IDEA ONE

West Side - Big Development

East Side - Big Scoop

West Side – Medium Development

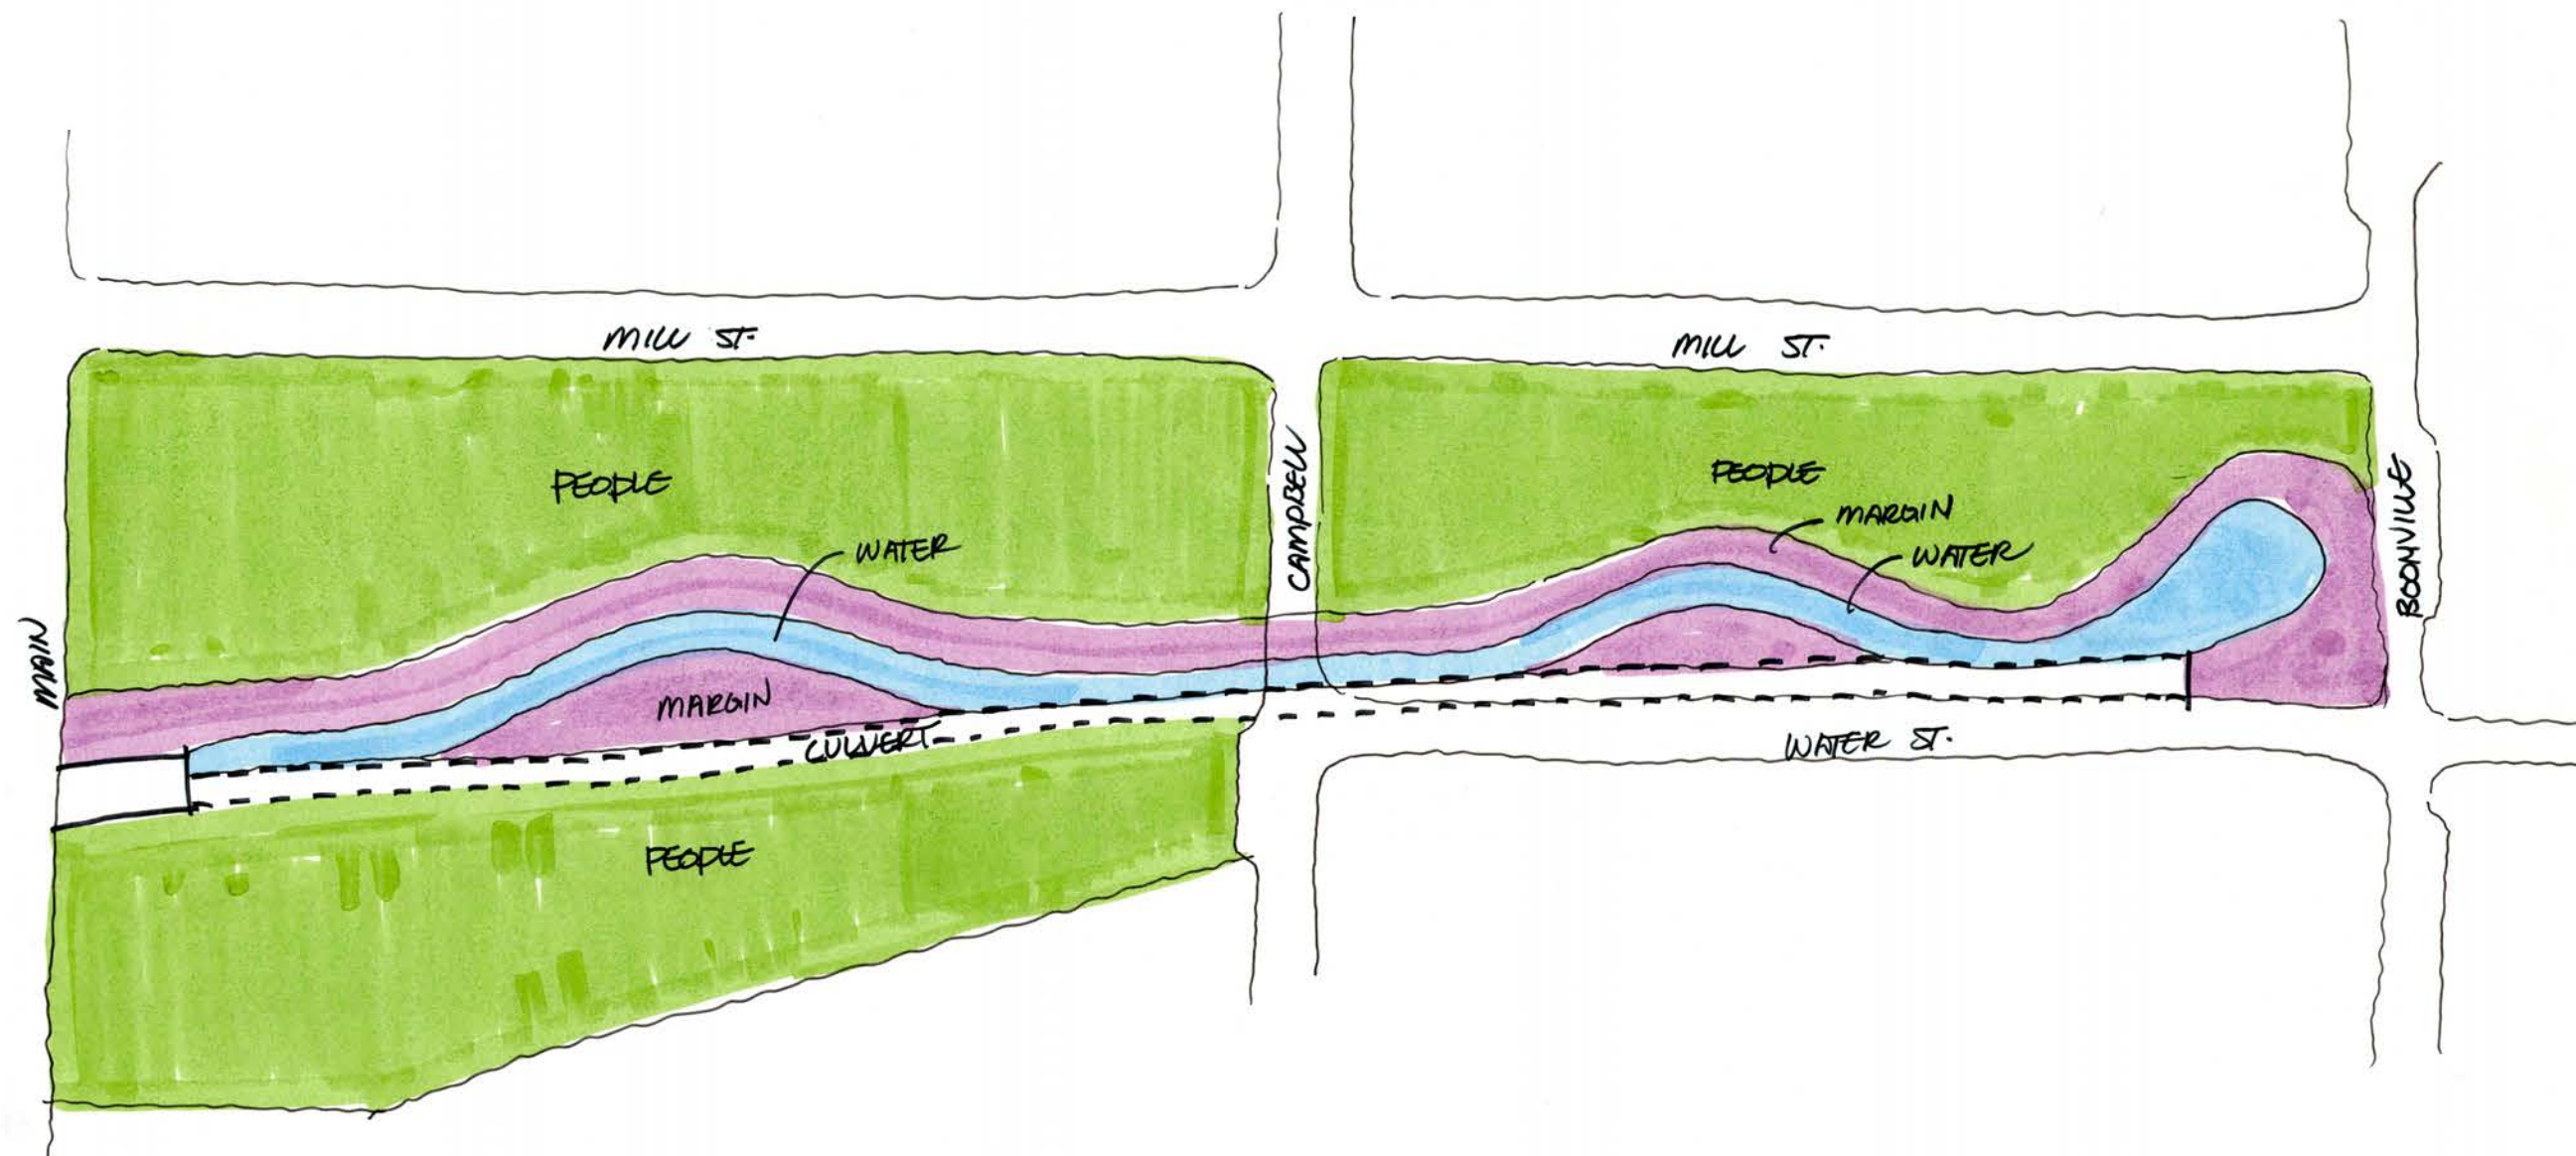
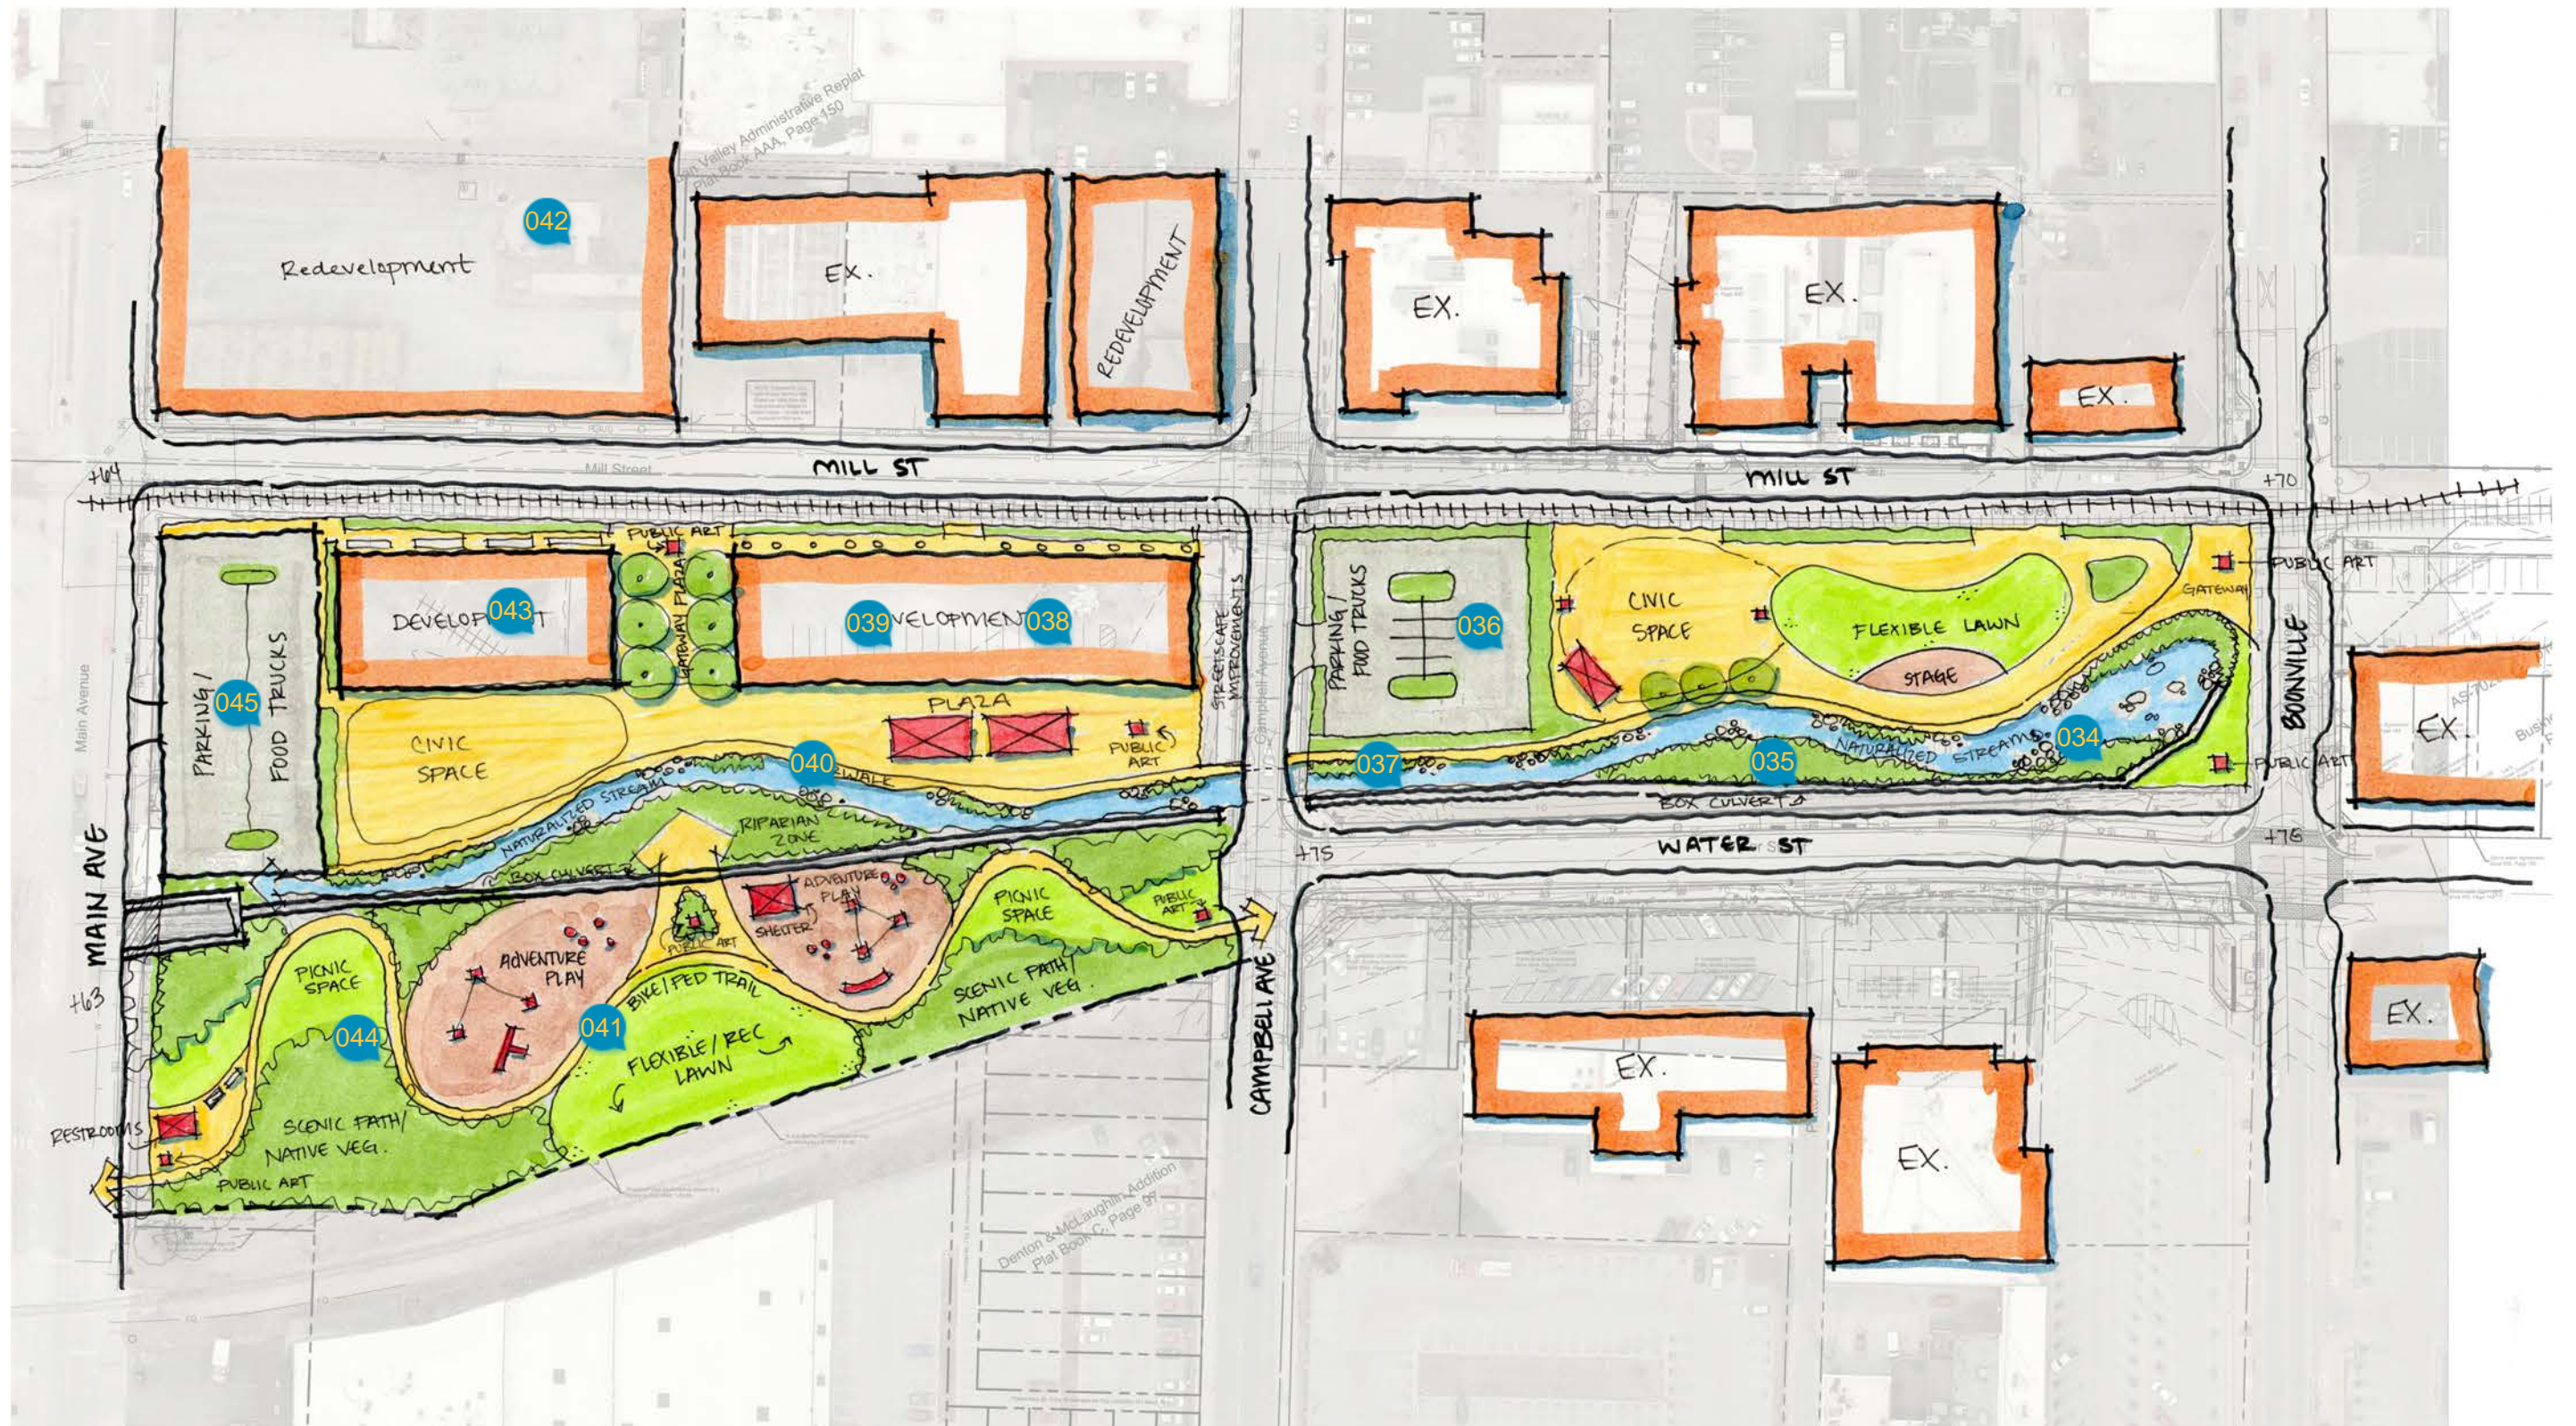
Box hugger needs to allow some plantings in between creek and wall to soften and provide riparian benefit. May be difficult to access for maintenance.

The more simple natural channel seems like it'd be more resilient to flooding (and post flood clean-up) than some of the other designs with pedestrian bridges and manicured plantings.

I'm concerned about parking as figural space, especailly along significant streets -- feels anti-urban

The box hugger concept has little meander and the section adjacent to the box would make it feel very "urban" i.e. large concrete wall next to a creek which would take away from the desire for a more natural park like space.

Development taking up too much public space and too close to the creek.

I wonder if "development" would be better on the south side of this site, away from the railroad track?

I don't like the idea of two parking lots within the amenity. You lose a lot of real estate to just the circulation part of this type of parking. I feel the single row of parking along the North edge is most efficient and disturbs the concept the least.

Yes. And up higher i.e. well above the floodplain. While the development itself would be elevated to meet the City's code for developing in the floodplain, it would present another obstacle in the way of floodwaters trying to move through this area.

IDEA THREE

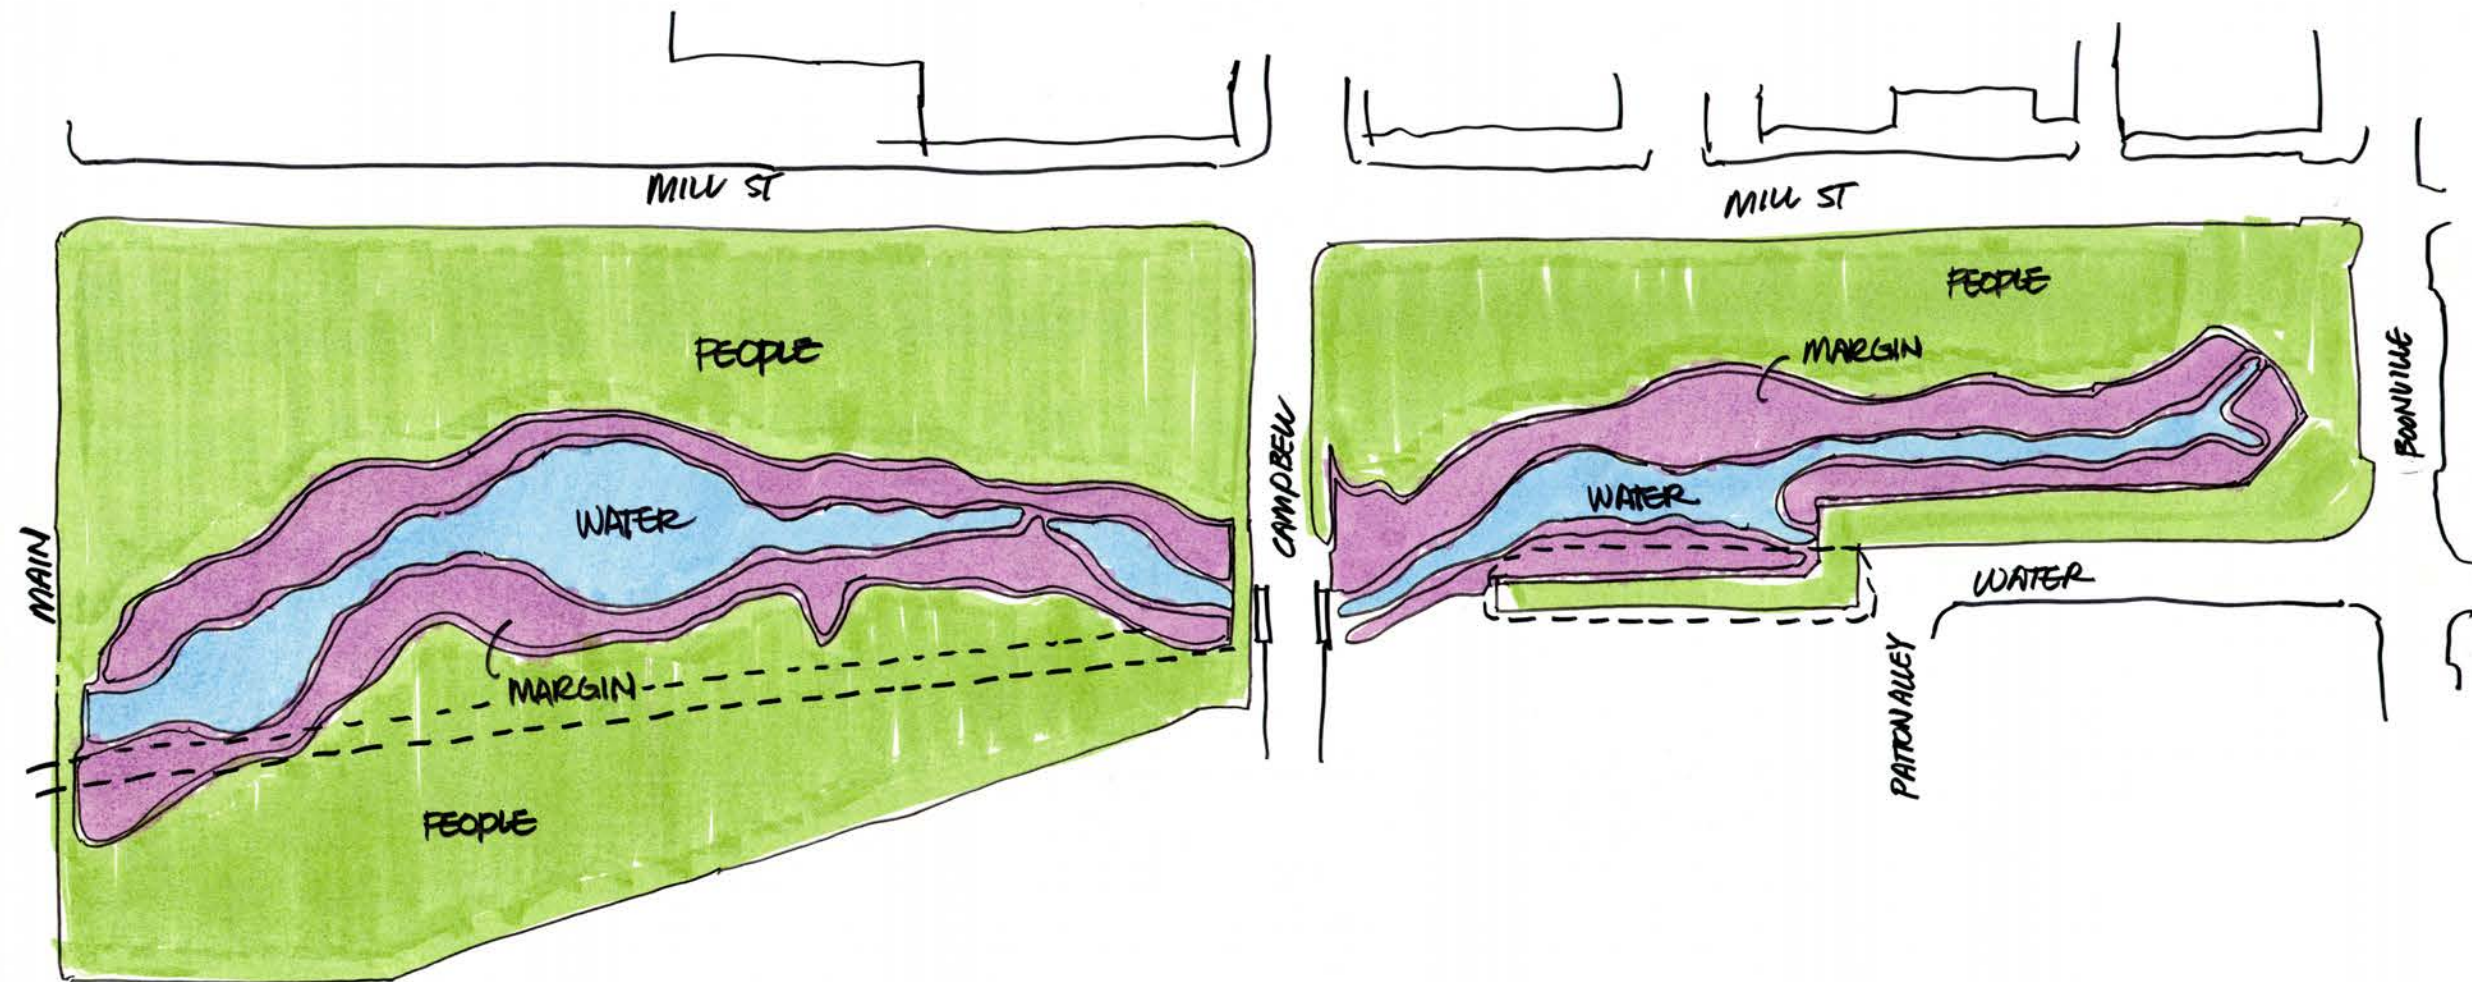
How will the Jordan Creek Greenway trail travel thru/by this space and then continue east to connect to the trail that begins at Jefferson Avenue?

Does locating a building here in the east-west direction improve access from Brick City, or does it hinder it?

whether its a grate or a boardwalk w/ open railing, how minimal could railings be? At what depth of water or drop off from path is a handrail required?

yes!! angled parking along street edge makes the most sense here. Consider how west moving traffic could still swing into these spaces, rather than spaces only being accessed from east-bound lane. Consider relaxing angle to find a sweet spot that works well for both directions of travel.

this water & margin space seems out of scale... to wide north to south?
